SUNDRY NOTICES AND REPORTS ON WELLS
Do not use this form for proposals to drill or to re-enter an abandoned well. Use Form 3160-3 (APD) for such proposals.

8. Well Name and No.
Bilbrey 33 Federal 1

9. API Well No.
30-025-30781

Bilbrey 33 Federal 1
ConocoPhillips Company
30-025-30781
12/07/2011
Conditions of Approval

Schematic - Current
BILBREY 33 FEDERAL 001

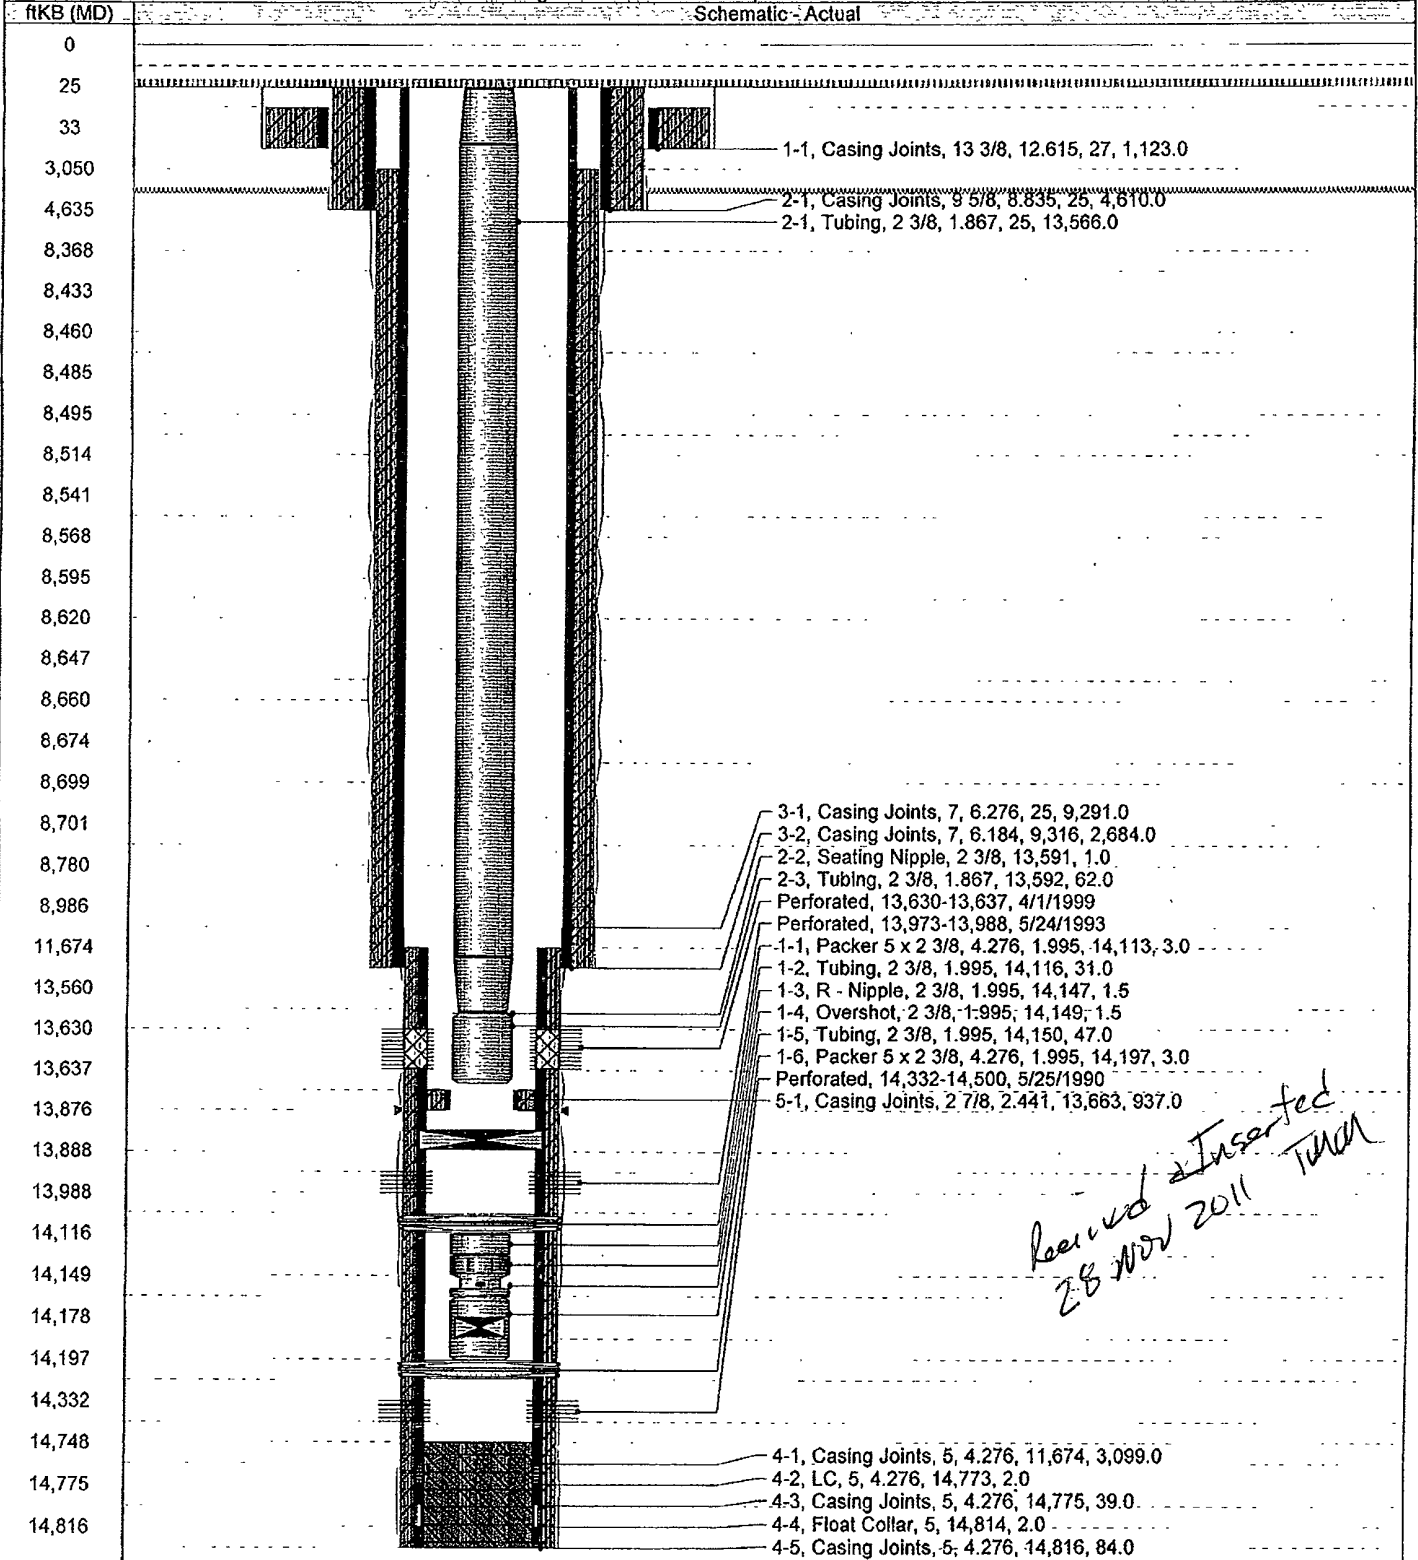
- Secretary's Potash
- Existing casing program:
 - 13-3/8" casing at 1150'. TOC surface, circ 200 sx
 - 9-5/8" casing at 4635'. TOC surface, circ 100 sx
 - 7" casing at 12000'. TOC at 3050' confirmed by temperature survey
 - 5" liner from 11674' – 13891' sqzcd TOL
 - sidetrack window at 13891'
 - 2-7/8" liner 13664' – 14599' Drilled 548' of cement on top of liner
- Open perforations 13991' – 14505' (Morrow, selective)

To abandon the Morrow in the sidetrack hole.

To recompleat and frac the Brushy Canyon 8840 – 8660' selective.

5. **STEP 7** - Set 2-7/8" CIBP at the revised depth of approximately **13940'** to isolate and abandon the Morrow perforations and the Top Morrow formation. Place 25 sx of Class H cement on the CIBP. Notify BLM for witnessing the tag. Tag must be 240' or more above the CIBP. NOTE: BLM guidelines require that the cement plug volume be at least 25 sx minimum.

6. **Step 8a** – Set a 5" cement plug at the revised depth of **12050' - 11624'** to isolate the Top Wolfcamp formation, the top of the 5" liner, and across the 7" shoe depth of 12000'. Notify BLM for witnessing the tag.

7. **Step 8b** – OPTIONAL. OK to set a 5" CIBP at approximately 8800' to establish the new PBTD at the proposed depth. Place 35' of cement on the CIBP, using a dump bailer. Notify BLM for witnessing the tag.
